## SECTION SF 30 BLOCK 14 CONTINUATION PAGE

**The following items are applicable to this modification:**AMENDMENT 3 VERBIAGE

## 1. This Amendment is being issued to make the following changes:

## a. Incorporate Questions and Responses posted to ProjNet into the RFP as follows:

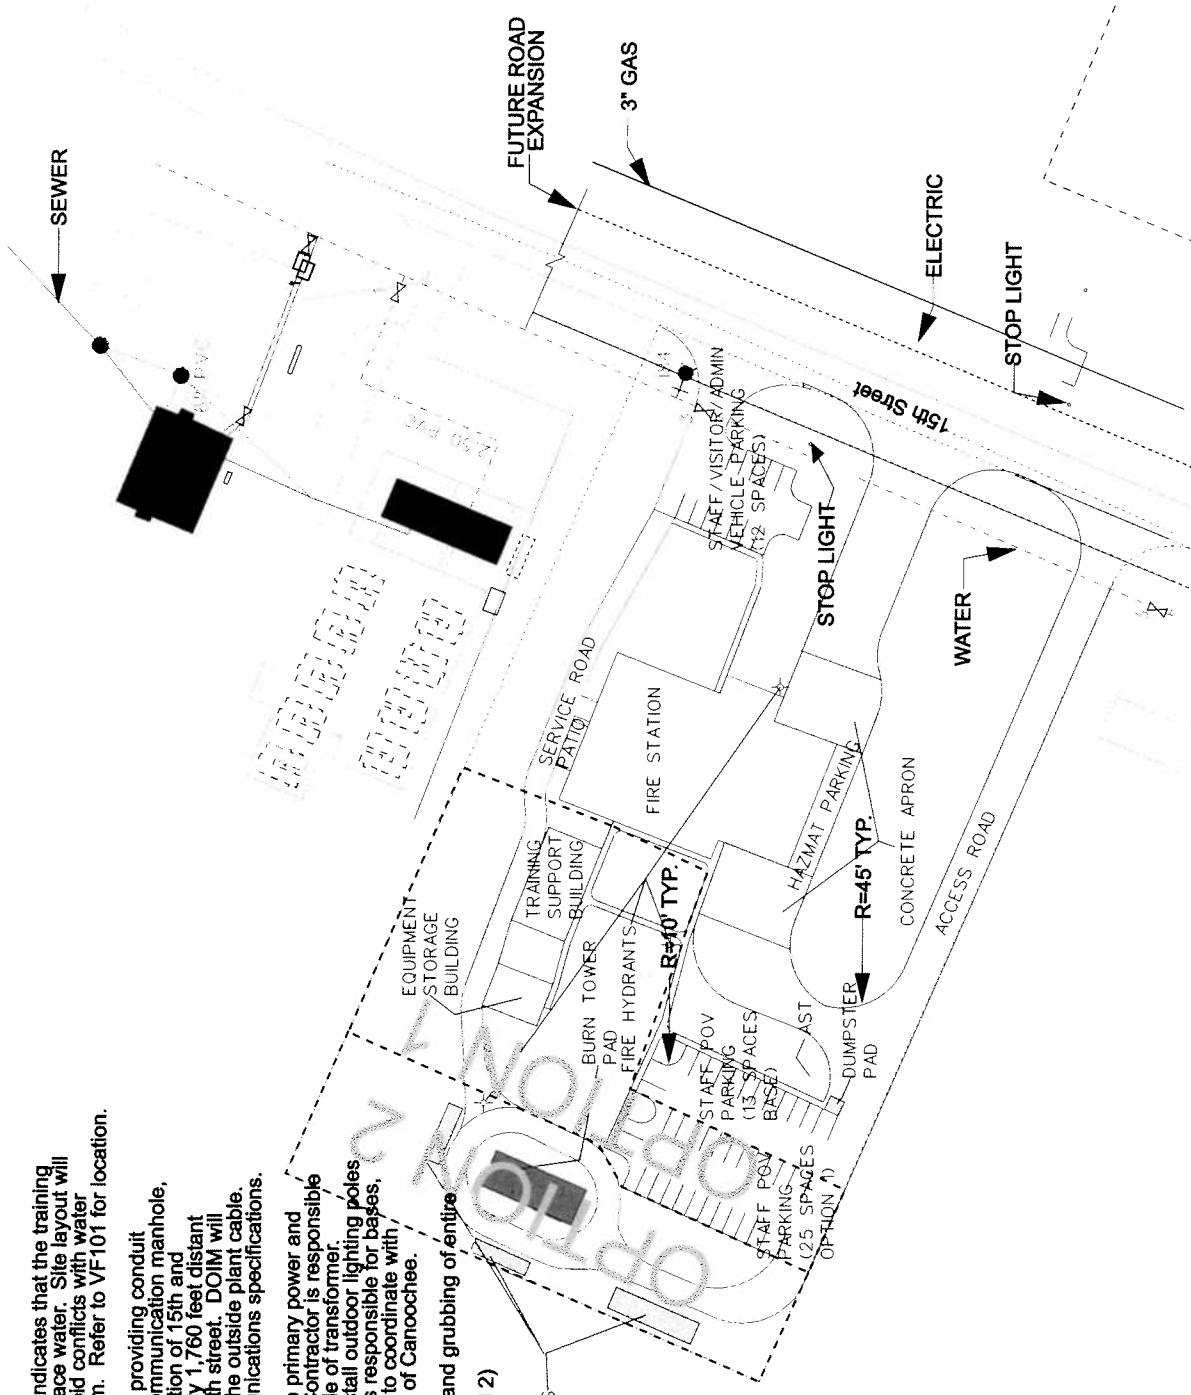
- Notes:**
1. Revised survey information indicates that the training area conflicts with existing surface water. Site layout will be revised as necessary to avoid conflicts with water bodies and the small arms berm. Refer to VF-101 for location.

2. Contractor is responsible for providing conduit and manholes to the closest communication manhole, which is located at the intersection of 15th and Essayons. This is approximately 1,760 feet distant from the project limits along 15th street. DOIM will provide, install, and terminate the outside plant cable. Refer to Appendix T for communications specifications.

3. Canoochee EMS will provide primary power and a transformer for the project. Contractor is responsible for connection to secondary side of transformer. Canoochee will provide and install outdoor lighting poles and fixtures only. Contractor is responsible for bases, conduit and wiring. Contractor to coordinate with Charlie Brewer (912) 272-1822 of Canoochee.

4. Base bid to include clearing and grubbing of entire project site (including areas encompassed by options 1 and 2)

This language has been added to drawing C-101 (attached) in Appendix J.
